1977 Corvette: Service Bulletin: Anti-Theft Alarm System Interim Modifications

Bulletin No: 77-I-38

Date: May 1977

FIGURE 1

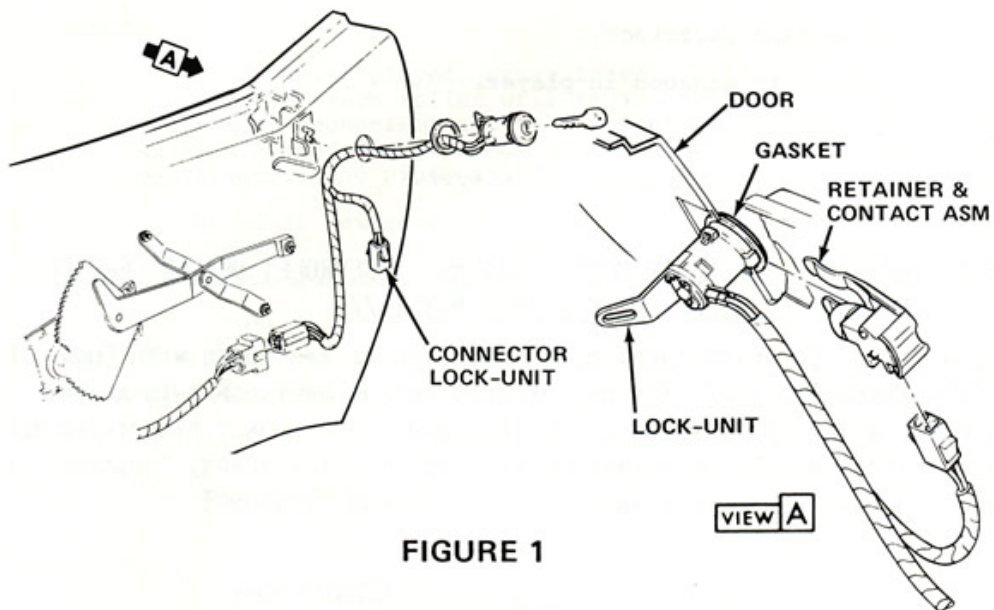
- The actuating switch for the system is no longer located on the left front fender. It has been incorporated into the left front door lock and must be activated by locking this door with the key from outside of the vehicle (Figure 1). This is the only way the alarm can be set. Turning the inside door knob to the locked position when exiting the vehicle will not activate the alarm system.
- The anti-theft alarm system horn has been moved from the left rear inner fender to the far left side of the engine compartment dash panel. (Figure 2).
- The anti-theft alarm system flasher assembly is now located on the console trim plate (Figure 3), rather than the rear compartment underbody panel.
- The new anti-theft alarm system wiring diagram is illustrated in Figure 4.
